***New Pump and Treat Facility Remedial
Action Work Plan for Test Area North
Final Groundwater Remediation,
Operable Unit 1-07B***

**DOE/ID-10679
Revision 1**

DOCUMENT TITLE/DESCRIPTION: New Pump and Treat Facility 90 Percent Design, Draft Phase C Remedial Action Work Plan, and supporting documents for Test Area North Groundwater Remediation

Figure 1-1. Operable Unit 1-07B trichloroethene contaminant plume.

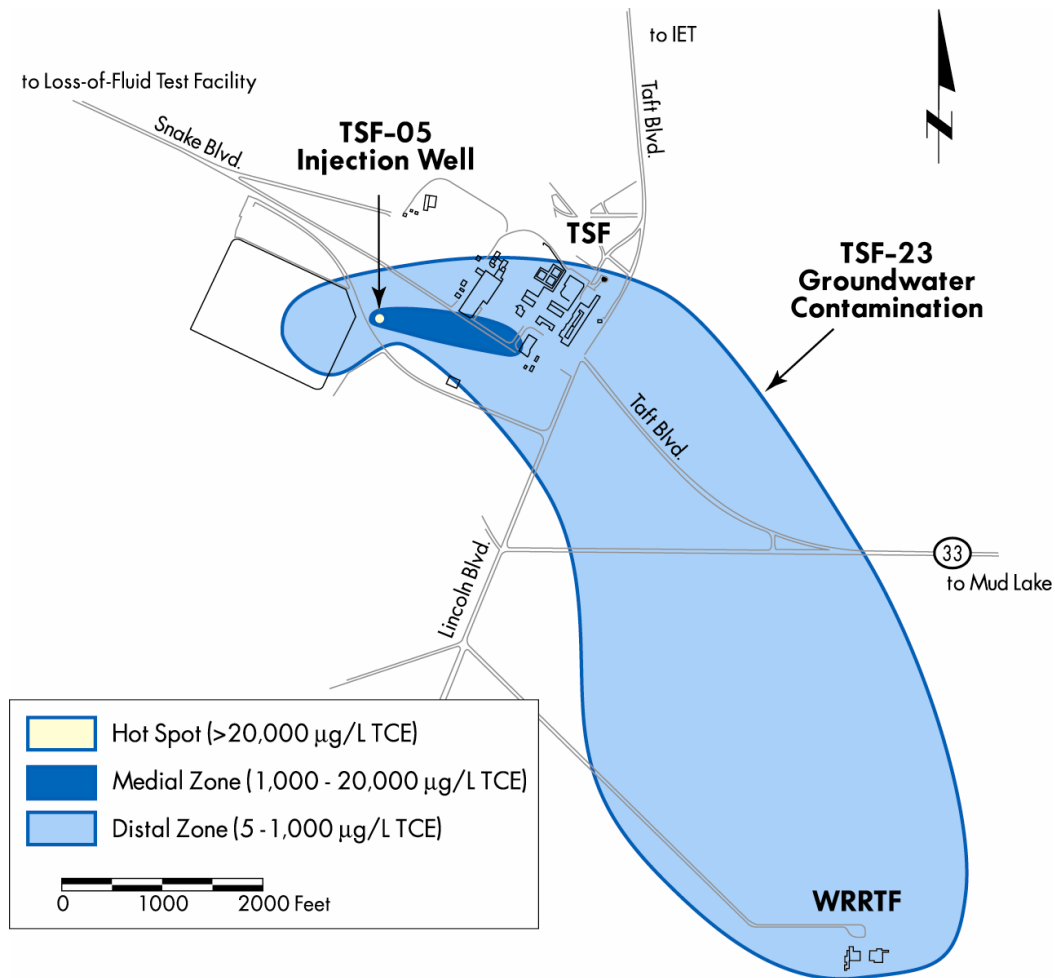
Idaho DEQ				
1	1-6 §1.3.1	Please correct the acronym "IDEQ" to DEQ	Text modified as suggested.	
2	2-2 §2.1.1.1	Please include a figure depicting the locations of the wells identified in this section so the reader does not have to find a separate document to view the spatial relationship of the wells.	Figure 1-1 replaced to include pertinent well locations.	
3	2-3 Table 2-1 Distal Zone MNA Compliance	The sample parameter needs to be updated to reflect the monitoring schedule in the MNA Workplan.	Table modified to match MNA Work Plan requirements.	
4	2-4 Table 2-2 Compliance Monitoring Remedy Compliance	The reference to influent concentrations below MCL's or reaching long-term steady state is too vague. DEQ would prefer a more specific definition of long-term steady state in the context it ensures RAO's are achieved.	The criteria used to make this determination will be evaluated and presented at a later time (during the project periodic reviews). These criteria will be reviewed and approved by the agencies prior to final acceptance.

6	2-5 §2.1.1.2 Table 2-3	Please include a figure depicting the locations of the monitoring wells identified in this table.	Figure 1-1 replaced to include pertinent well locations.
